DUNE APA shipping packing update

CERN's 2/9 summary of the revisions

Height

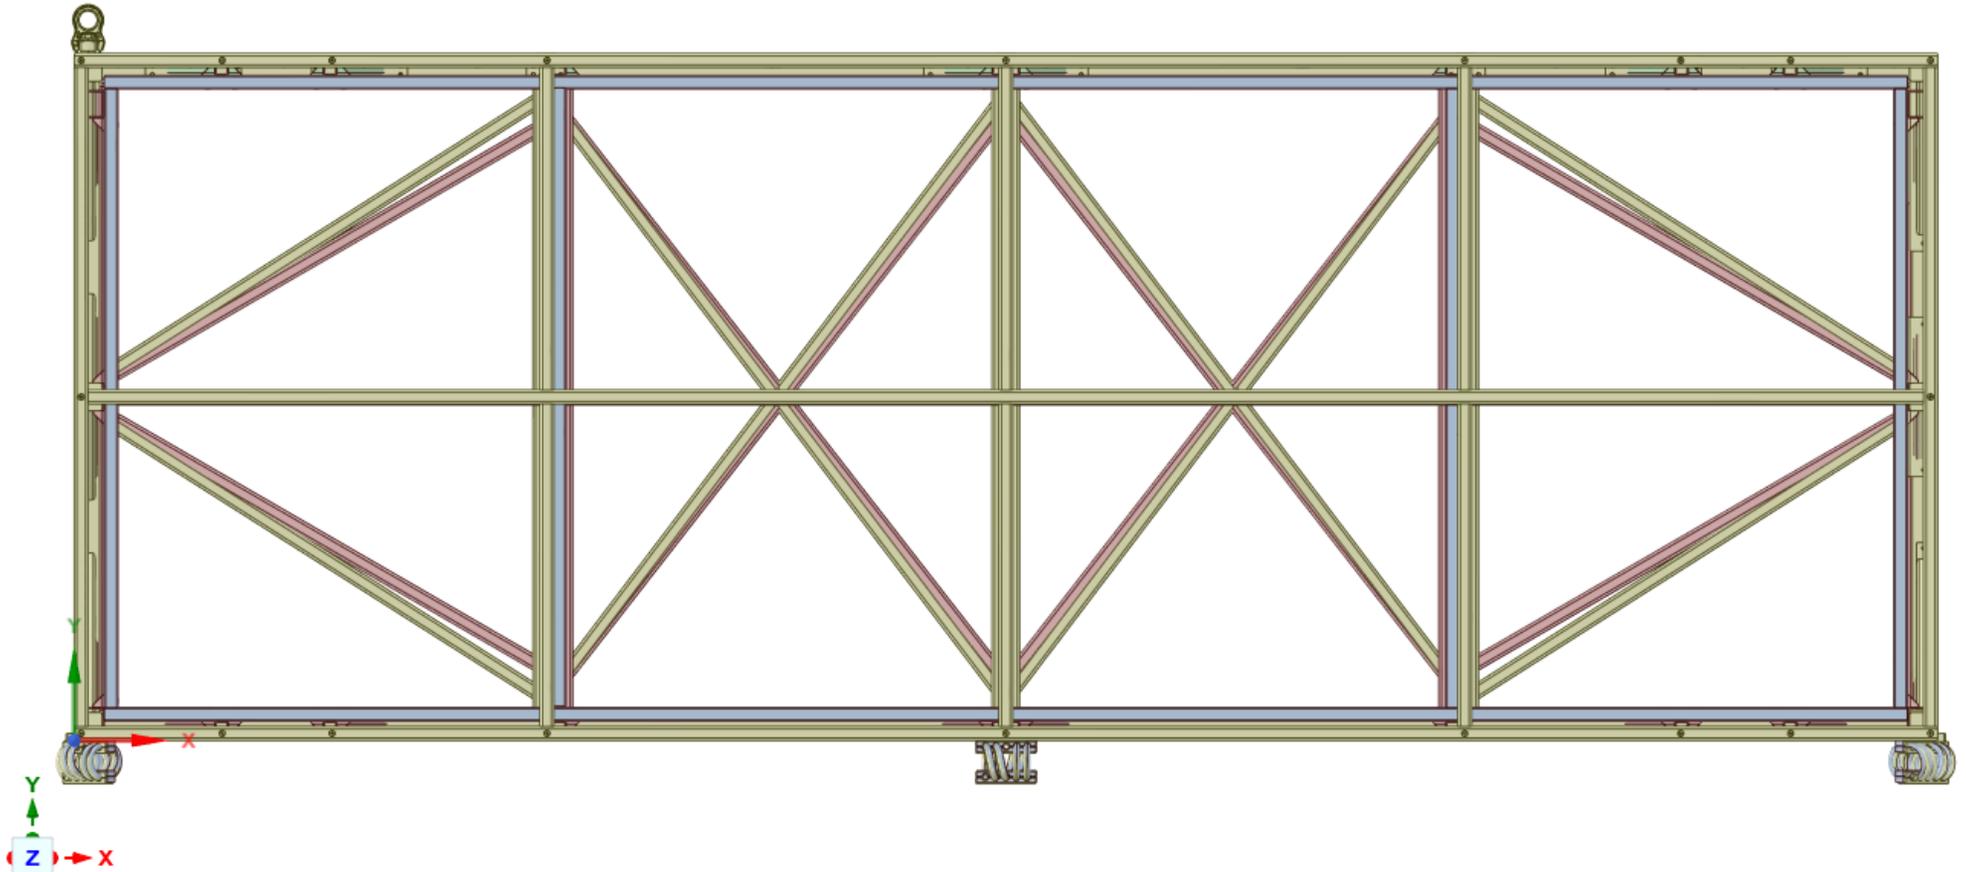
1. Height
2. Inclination of the diagonal bars at both end sides of the SF was increased to allow for access
3. The cross section of the Longitudinal central-top bar was increased.
4. The attachment of the lateral frame was changed.
5. Parts of the structure were made removable
6. Plates were added between orthogonally welded sections.”

Inclination of end side braces

Lateral frame attached on the edge of central frame tubing

Detail C

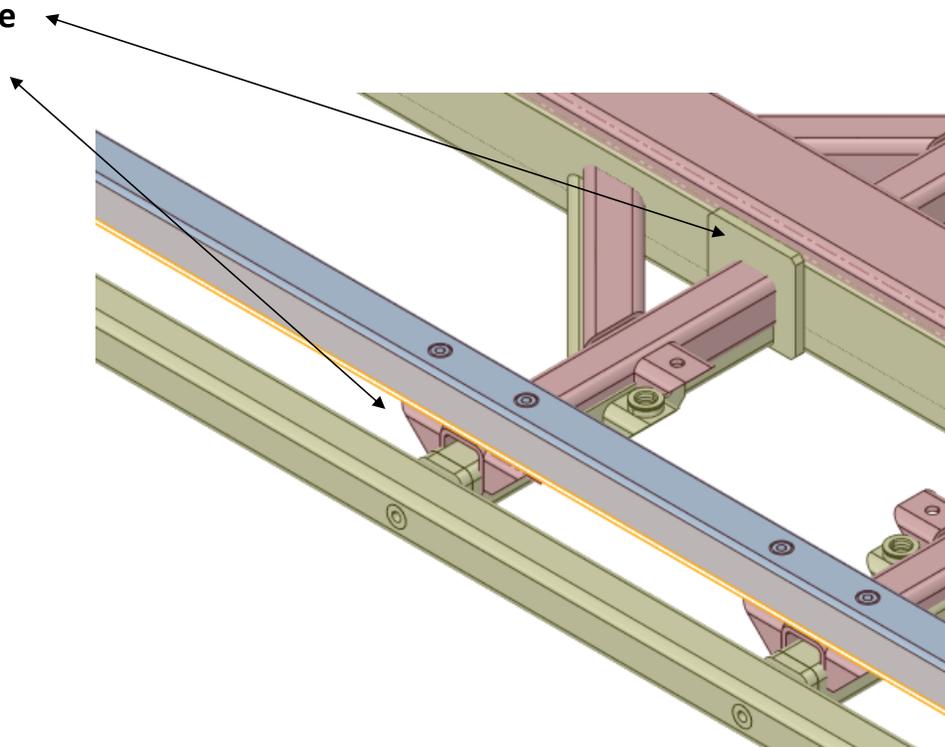
Tube-tube reinforcing plate

Lateral frame attachment

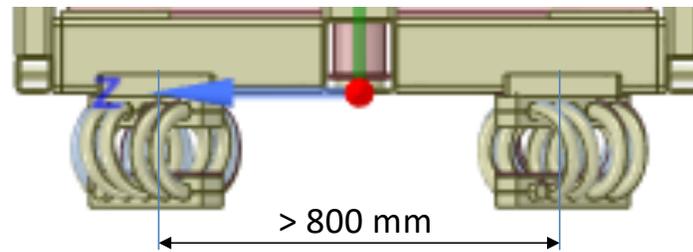
1. Lateral spacing of the WRAs must be 800mm inter-axis. Thus, the position of each WRA must be shifted 120 mm towards the exterior. This is necessary in order to limit the dynamic lateral displacements.

The shift from 560 to 800 mm c2c spacing

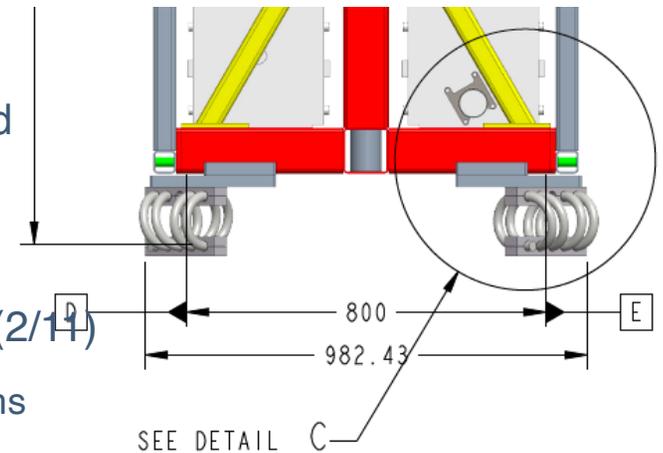
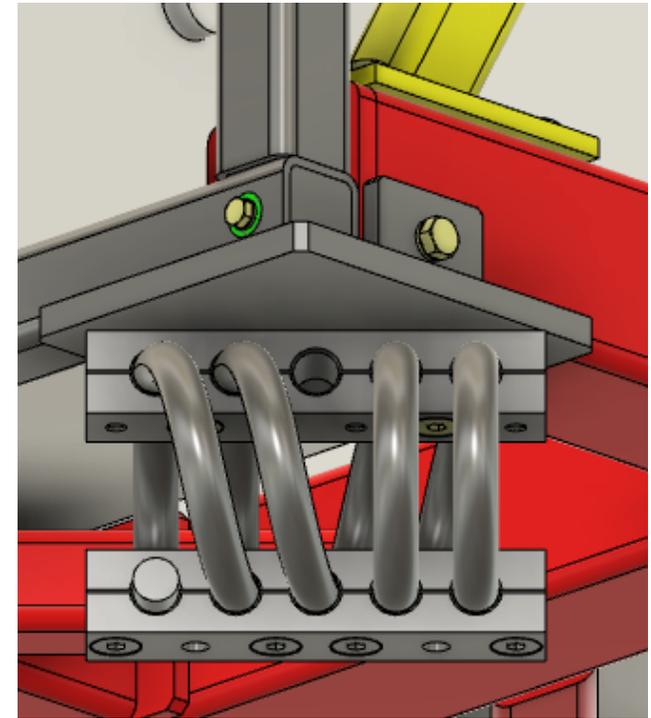
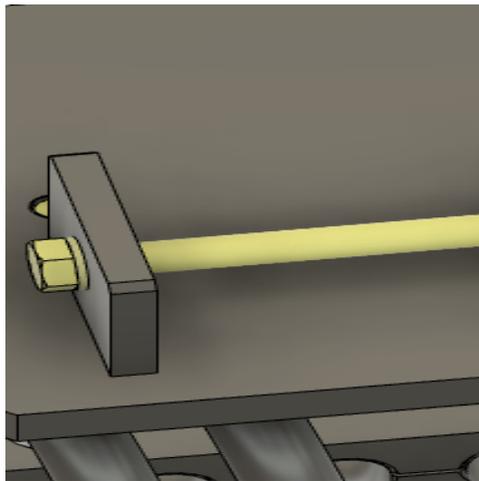
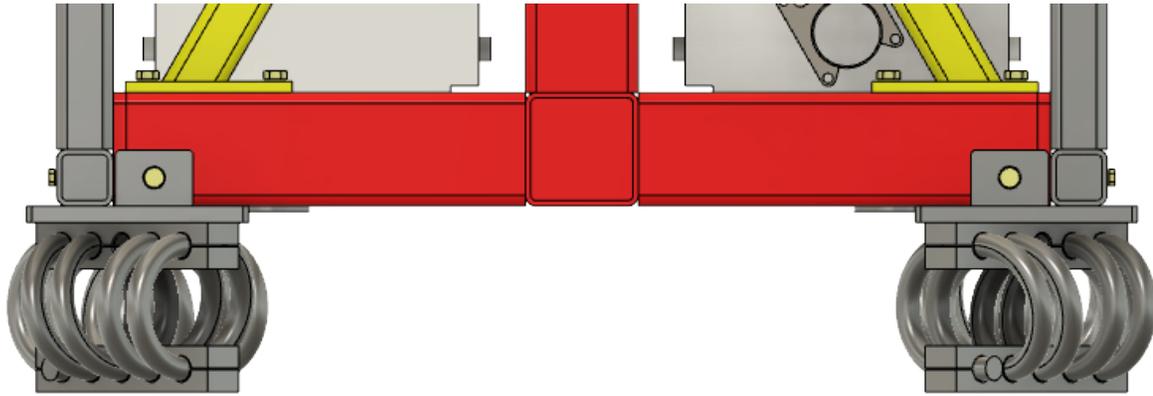
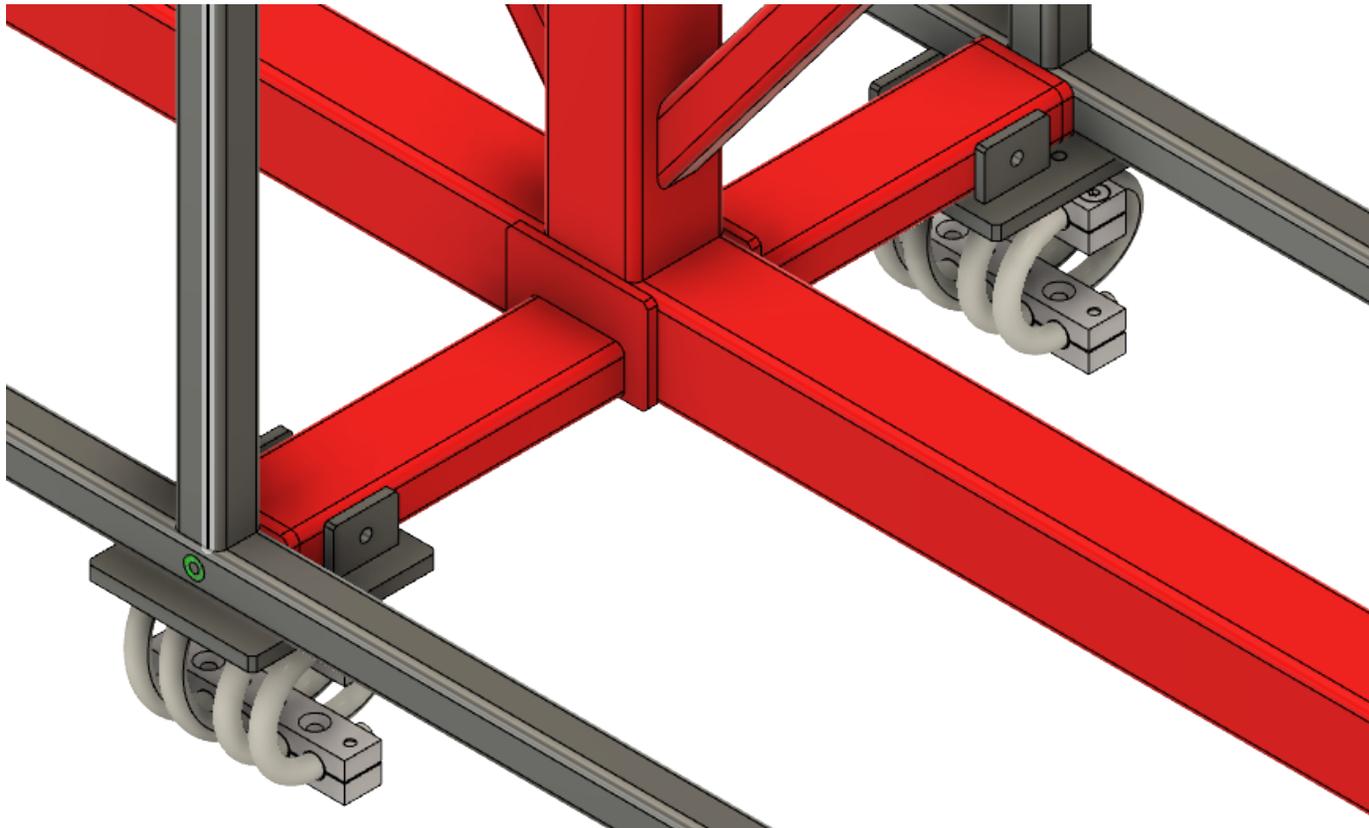
- Clearly an important aspect of the design
 - Note that the CERN frame was 800mm wide – and delivered without placed isolators
- This ended up not being straightforward
 - George made a “scenario drawing” to show that placement (2/14)
 - Necessitates plates that cantilever the isolators beyond the arms
- By 2/19 George and Benoit converge on a revised isolator mounting scheme
